**Board of Adjustment
Special Meeting Agenda
Fraser Town Hall, 153 Fraser Avenue
Wednesday February 26, 2025
5:30 PM - 6:30 PM**

a. Appeal Of Administrative Variance Denial - The Ascent

MAJOR SITE PLAN
THE ASCENT

RE: The Ascent – Final Plat, Major Site Plan, Administrative Variance
Planning Review Comments (1st Referral Review)

LANDSCAPE PLAN

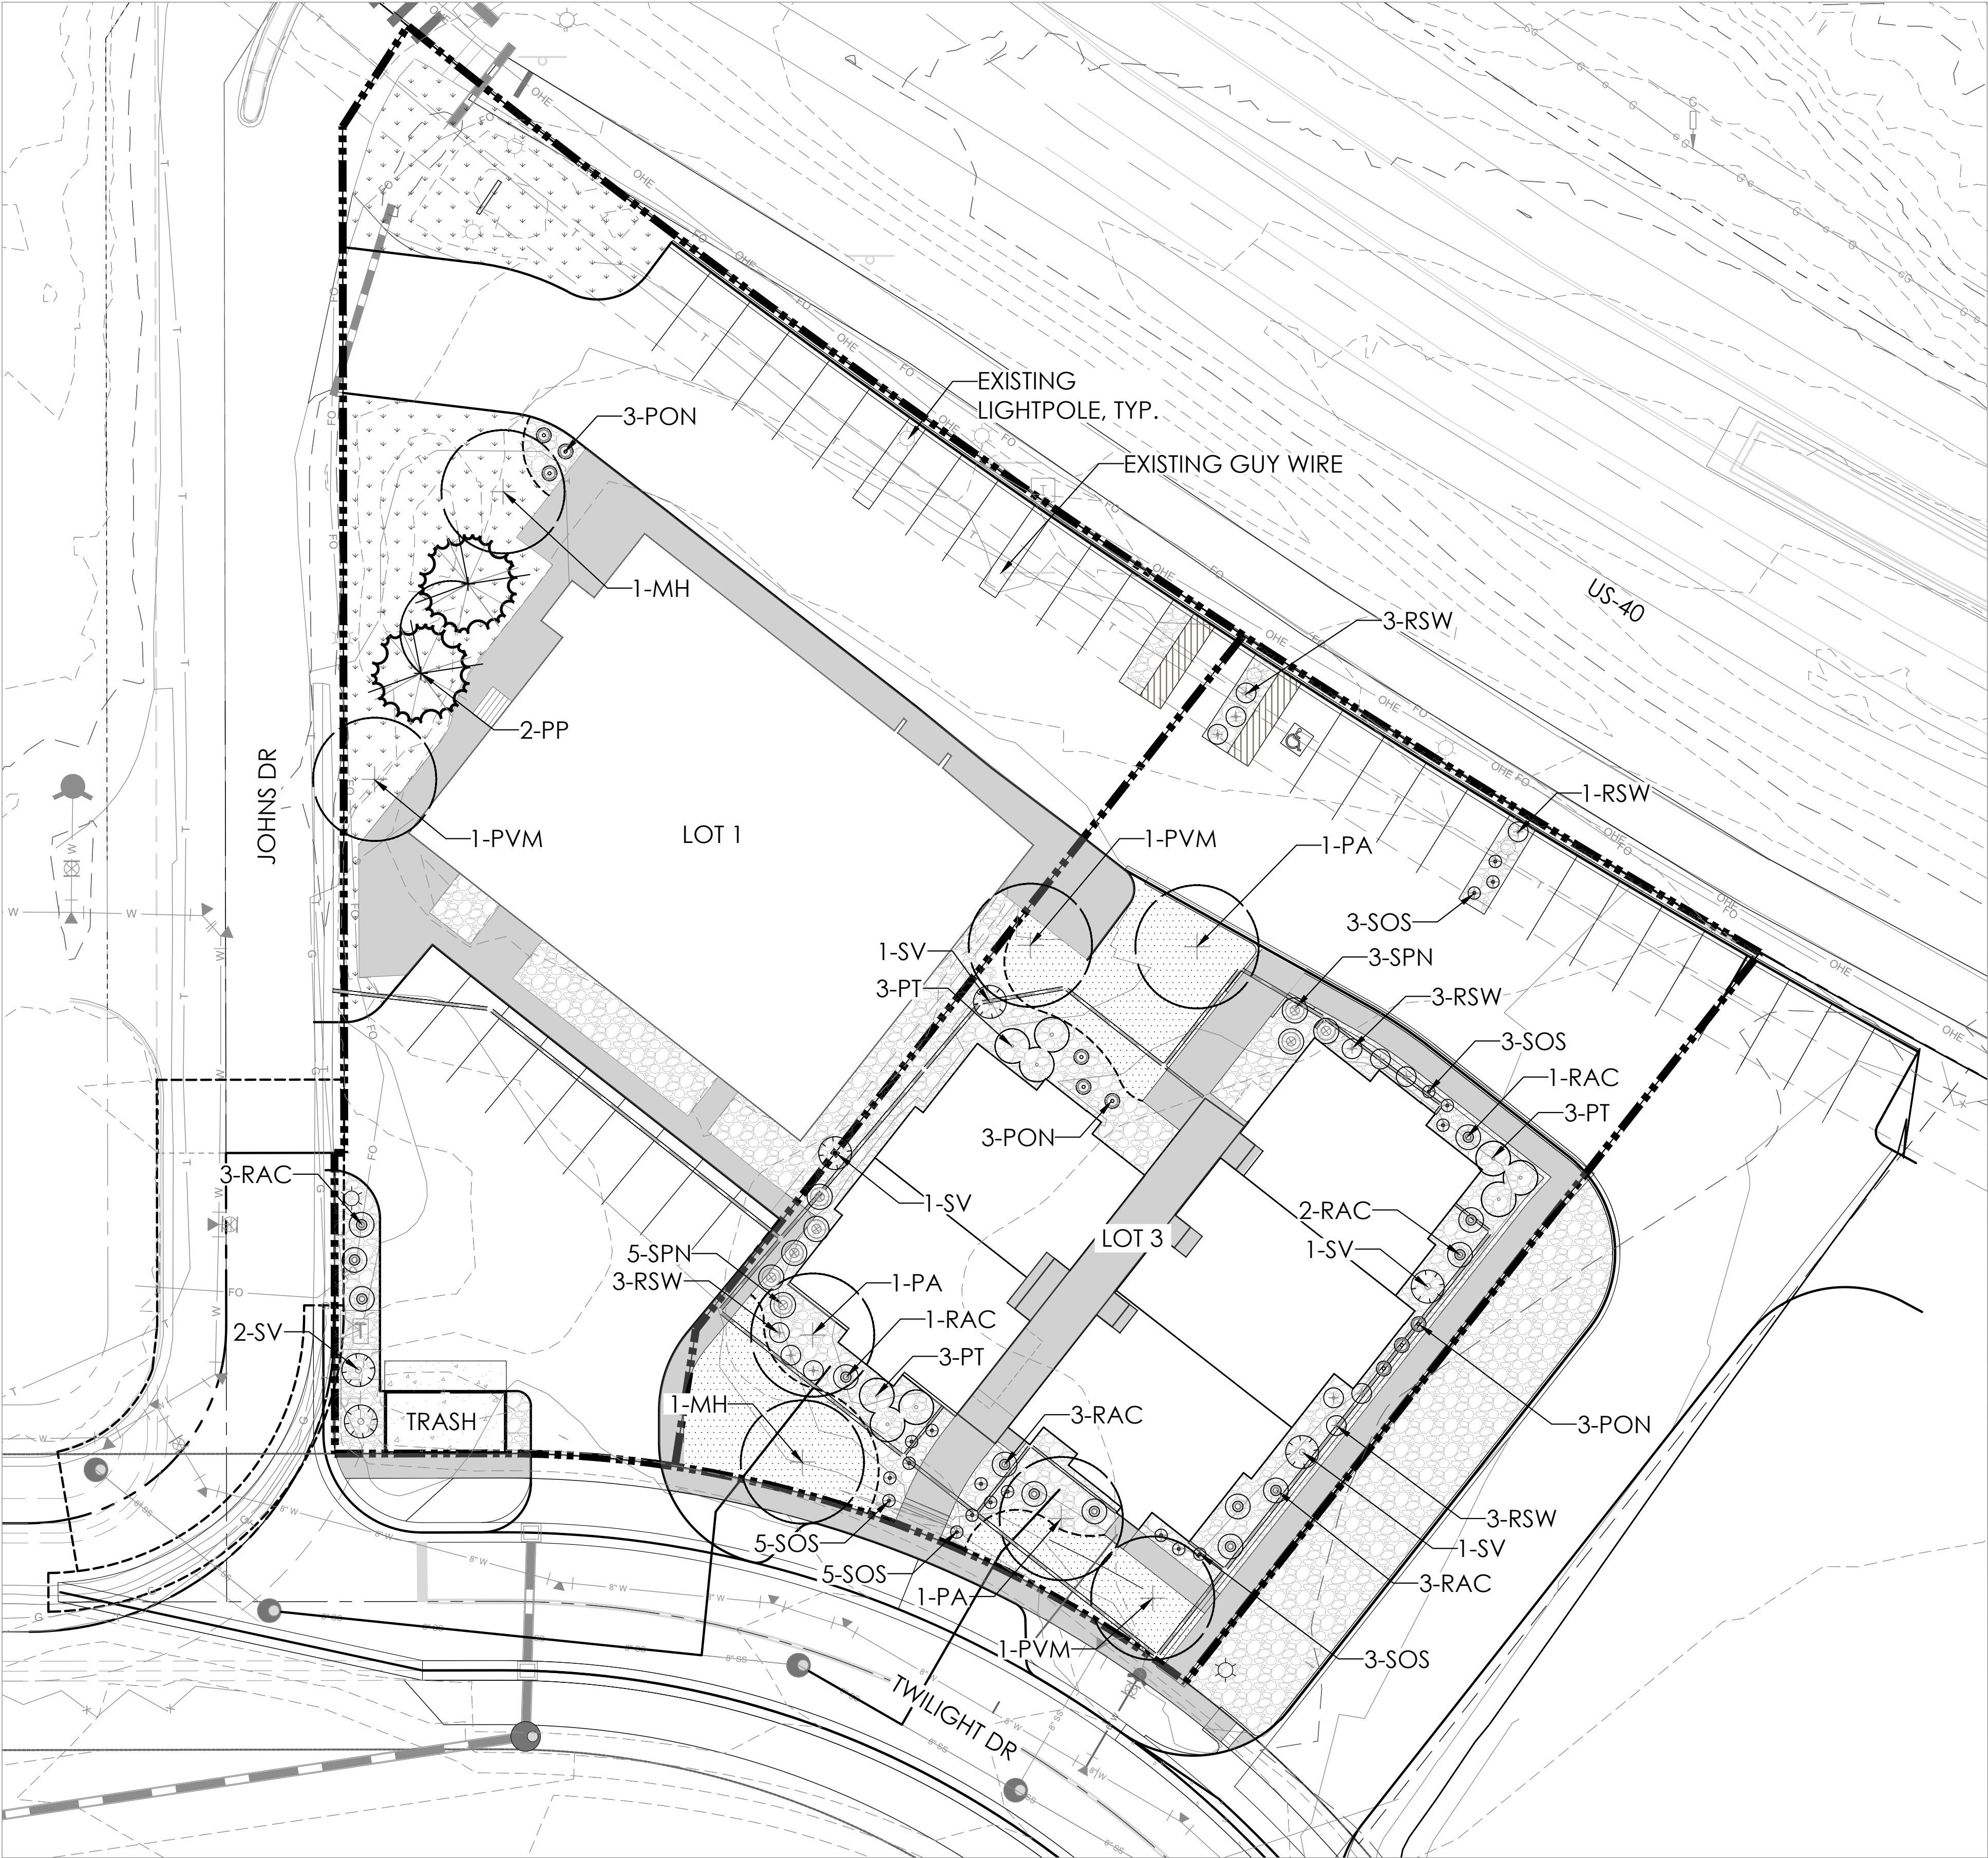
Sheet 3 – Landscape Plan

- 34) [Sec. 14-5-40\(10\)](#) requires parking lot interior landscaping islands for parking lots with twenty (20) or more parking spaces at a ratio of one hundred (100) square feet and one (1) tree and two (2) shrubs for every ten (10) parking spaces. Please provide additional interior landscaped islands within the parking area on the northeast side of the site, similar to the two that are proposed at either end of the southeast row of parking.

- 35) Provide the following as required in [Sec. 14-5-40](#) - landscaping specifications:
- Provide an irrigation plan, if irrigation is to be provided.

- Include a statement providing that the owner and his or her heirs, successors and assigns will provide adequate maintenance for all site elements. Landscaping maintenance shall include irrigation, fertilization, pruning and noxious weed control.

- Include contact information on who prepared the landscape design. A landscape plan drawn by a landscape architect or designer is preferred but is not required.

- 36) Please provide a cost estimate of the proposed landscaping subject to the following requirement from [Sec. 14-5-40\(11\)](#). This amount will need to be included in the collateral collected as part of the DIA:

LIGHTING PLAN
January 29, 2025
SHEET 13

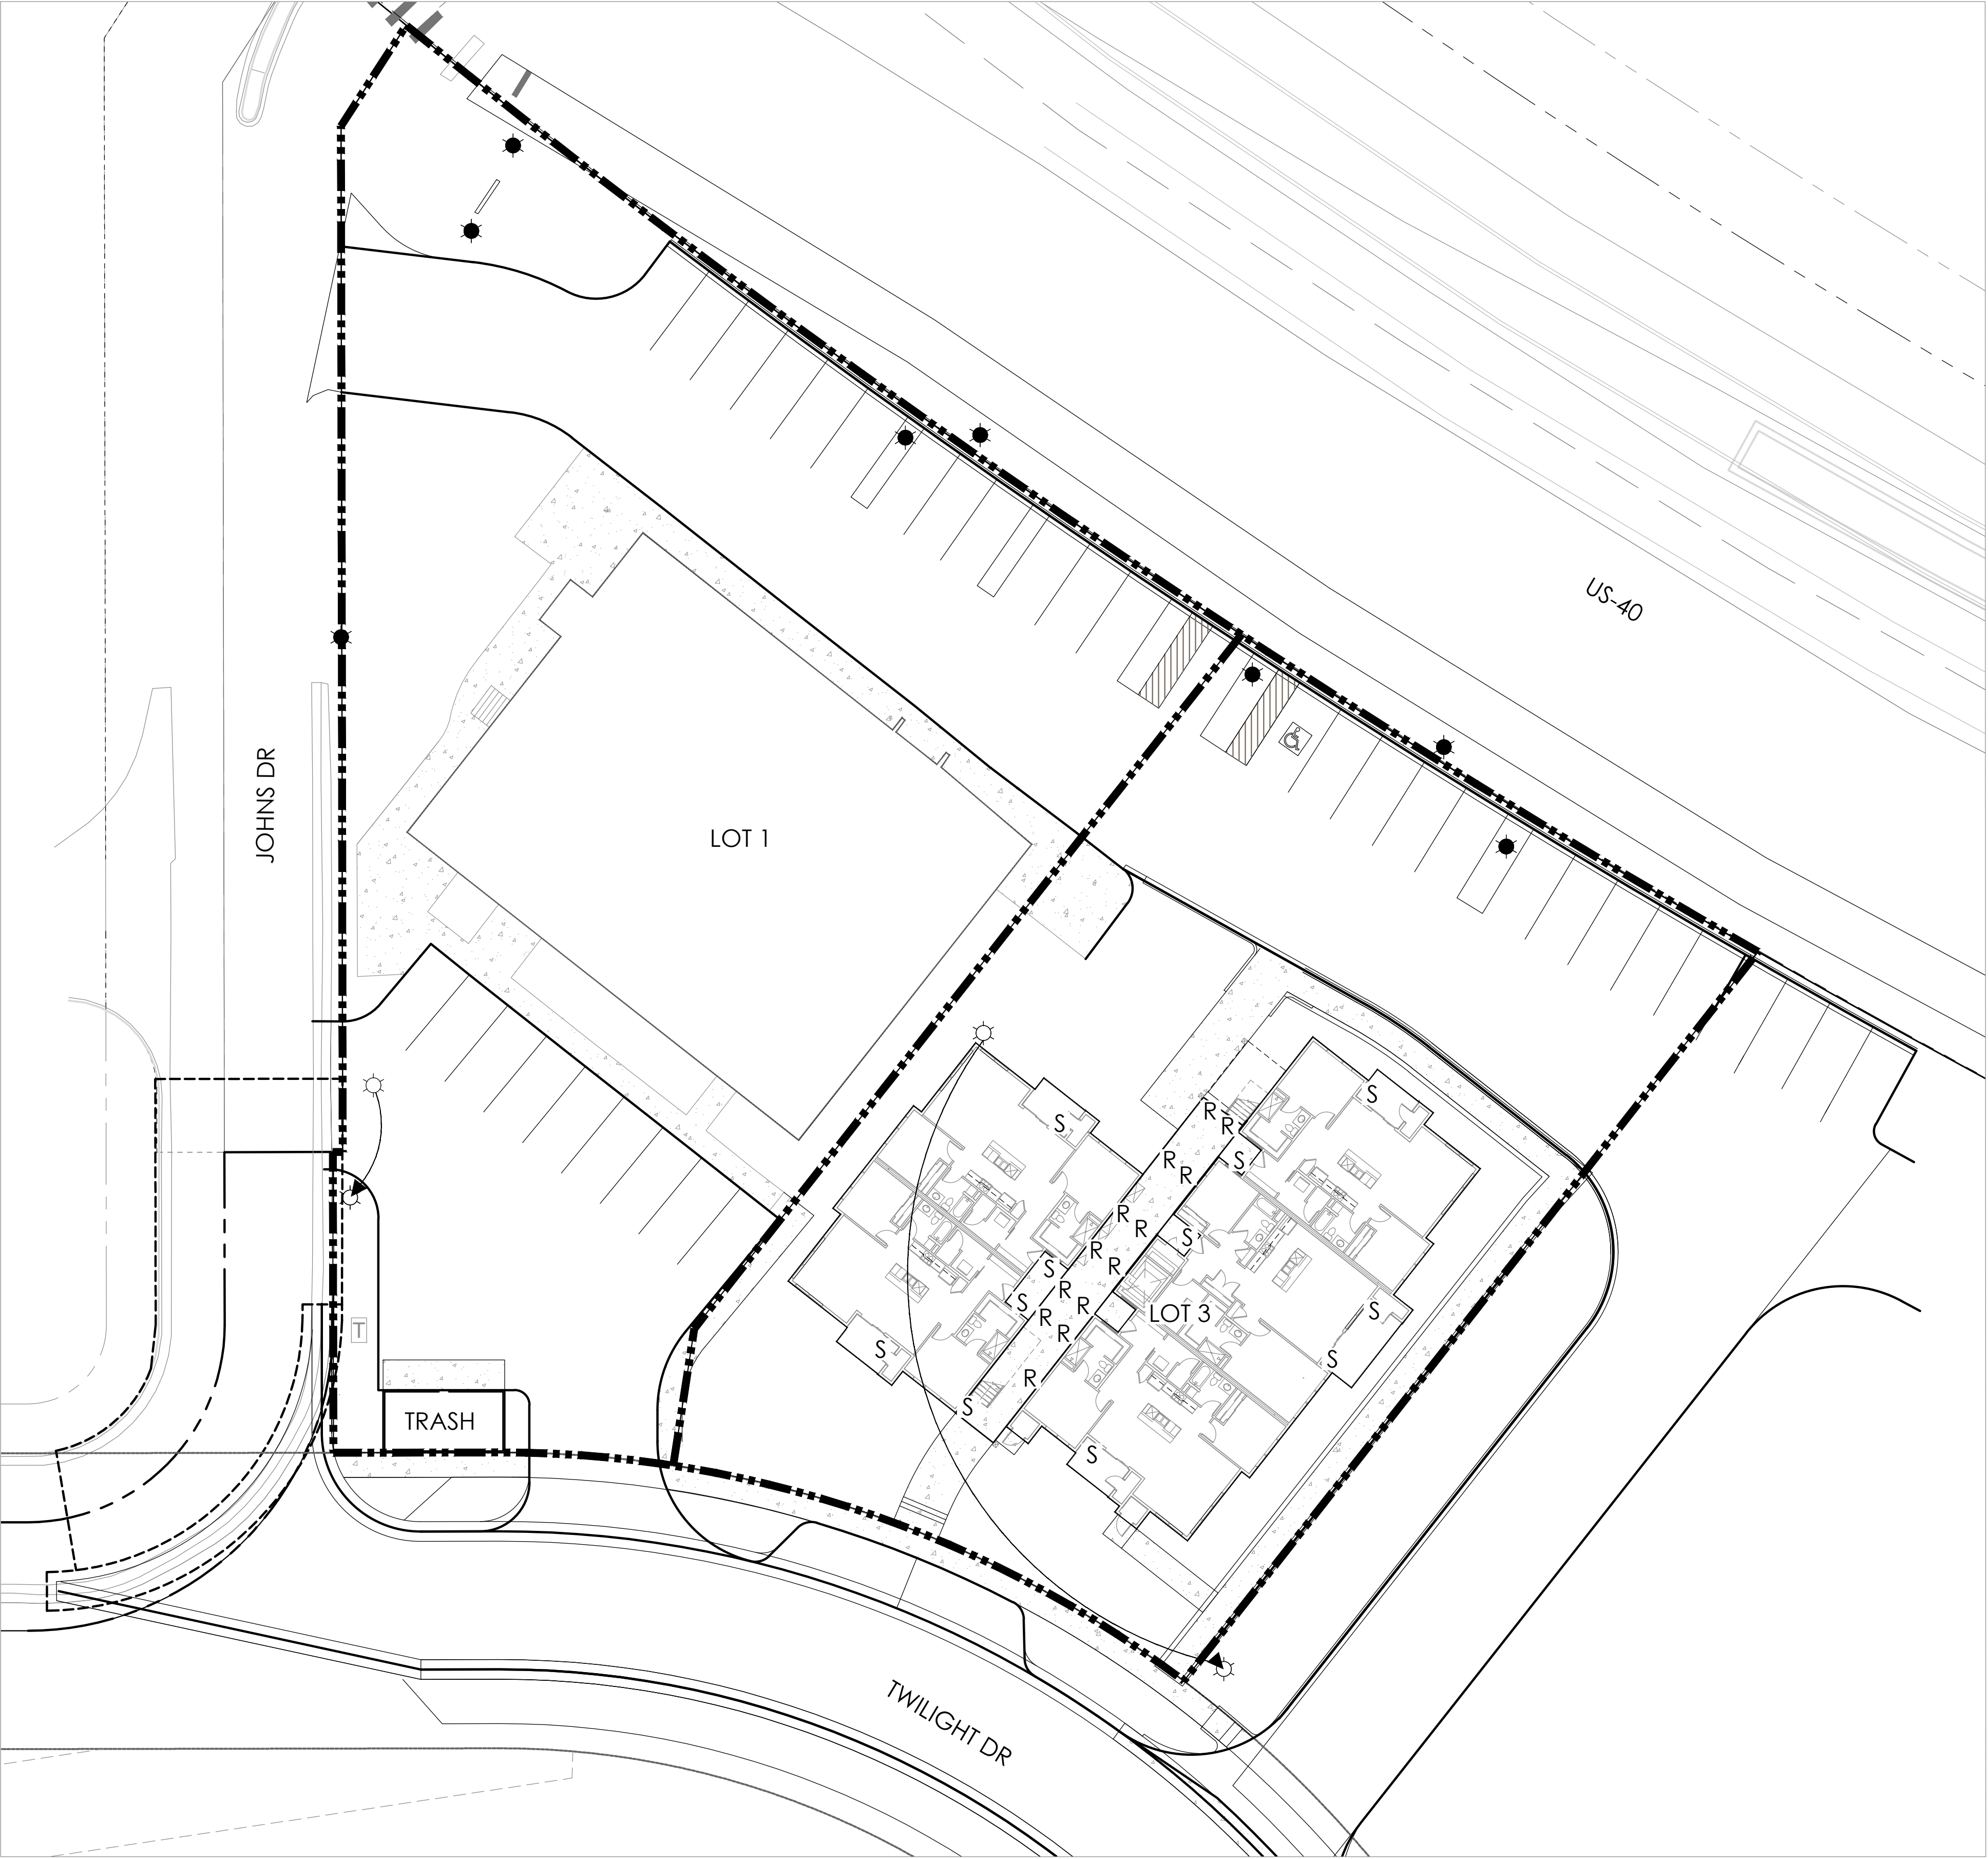
Sheet 12 – Lighting Plan

- 39) [Sec. 14-5-30](#) and [Sec. 19-4-195](#) include site lighting requirements and guidance for sites in the Business District zone. Lighting is to be appropriate for public safety and security, while minimizing undesirable effects of excessive illumination such as glare, sky glow and light pollution.
- a. The lighting plan provided only depicts existing pedestrian and parking lot lighting on the east side of the site. Please update the plan to include detail sufficiently addressing items 1 through 8 in Sec. 14-5-30.
 - b. You may incorporate the photometric plan as required in item (8) into this sheet.
 - c. Additional parking lot lighting is suggested for the southwest and southeast parking areas to provide minimal levels for pedestrian safety.
 - d. Please be sure to include any exterior lighting that is to be provided on the building exteriors into this sheet.
